Re: Western Sydney Stadium - Response to Stage 2 DA Comments
Attachment One – detailed Comments
'Landscape & Public Domain

Council has reviewed the Landscape Drawings prepared by Aspect and raise the following key concerns with the proposed design.

Extract of revised Masterplan, highlighting new East-West pedestrian link

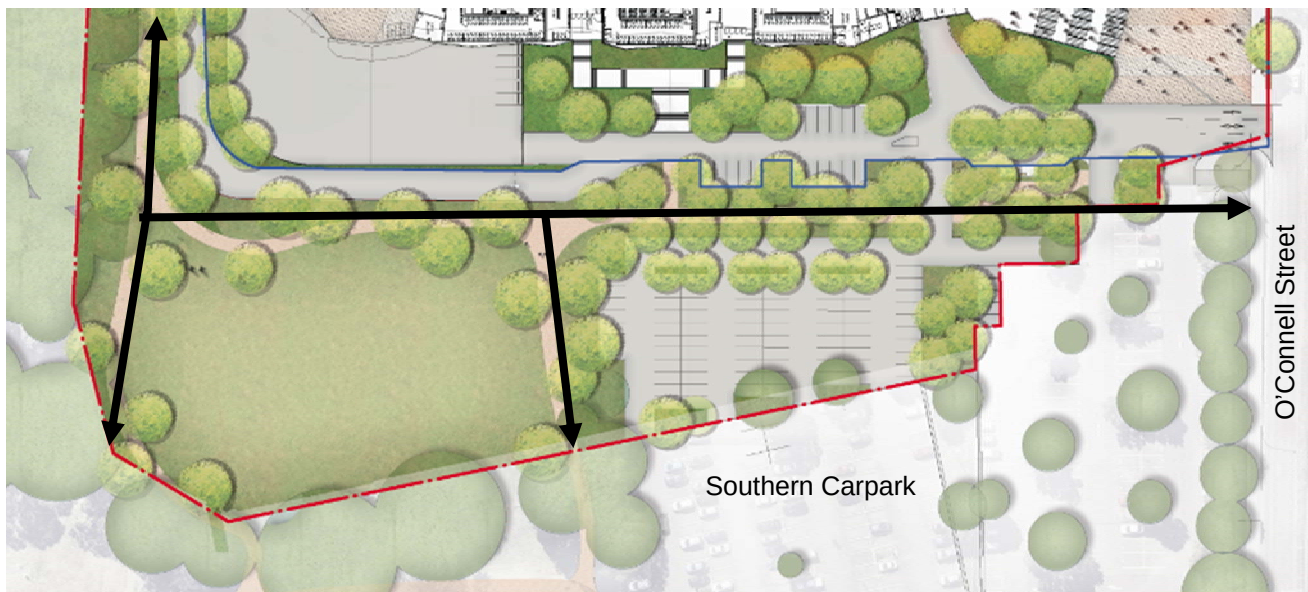
· That the design consider improving pedestrian connections through the southern car parking area between parklands and O'Connell Place to facilitate the 'peoples loop'; and

A dedicated East-West pedestrian link has been included to the south of the stadium. This sits in a wide median which includes a combination of planted and grassed understory with shade trees along its length. This walkway will also include appropriate pedestrian lighting. This walkway will provide a strong link to O'Connell Street, O'Connell Place and the parklands to the south and west of the site.

The southern access roads to the loading dock and Western Carpark / Old Kings Oval have been grouped to form a single access road, allowing more space for pedestrians and to enhance the 'parkland' experience of this part of the site.

- 1 – Terraced Childrens Play Area
- 2 – Multi-use areas including options for,
 - Outdoor fitness,
 - Skate
 - Table tennis
- 3 - Amphitheatre

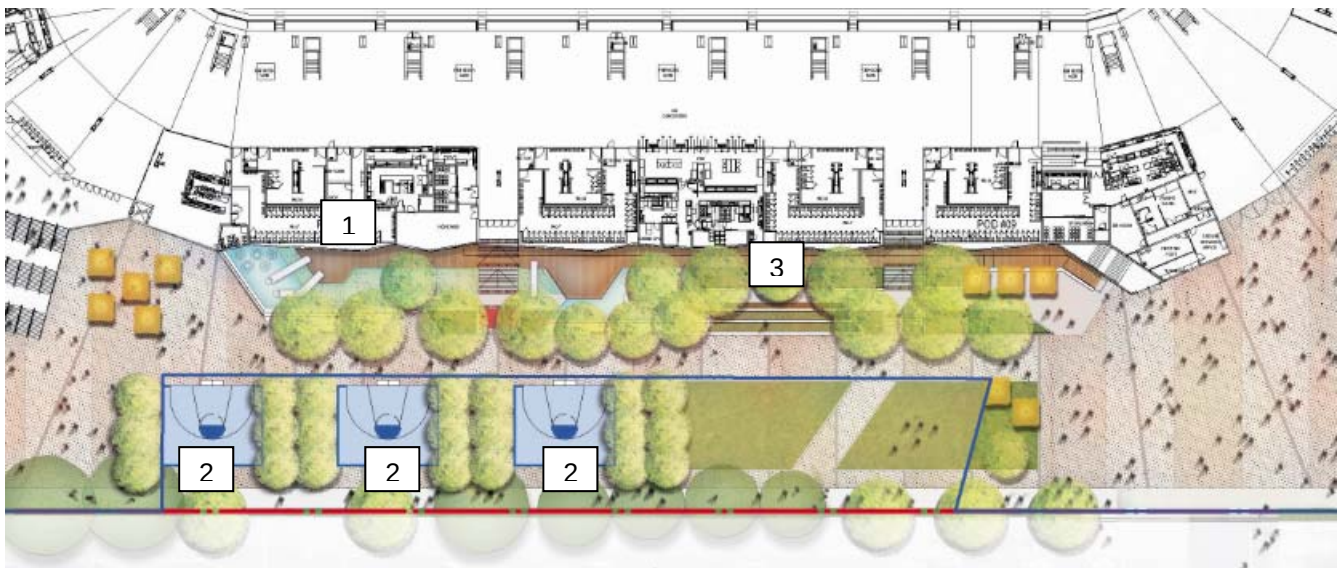
· Reconsider inclusion of lawns at O'Connell Street with paved areas, integrated multiuse sport courts and other dynamic uses that make this space a 'destination'.

The design of the O'Connell Street forecourt area has been revised to include multi-use half courts, and a terraced area including children's play opportunities.

The children's playground area is envisaged to include to a variety of play elements including, slides, climbing nets, sloped climbing walls, appropriate playground style trampolines, and spinners. These elements will be integrated with the terracing to create a variety of play opportunities and experiences for children across a range of ages, and to minimise the impact of the level change from concourse to plaza. Low steps and bench seating provide places for parents and children to rest and watch the play.

Accompanying these active areas within O'Connell Place is an amphitheatre area with a combination of low grass terraces with integrated seating edges. Both areas provided opportunities for visitors and workers from the stadium to rest, picnic and observe the passing parade, while the amphitheatre could also be activated for small performances.
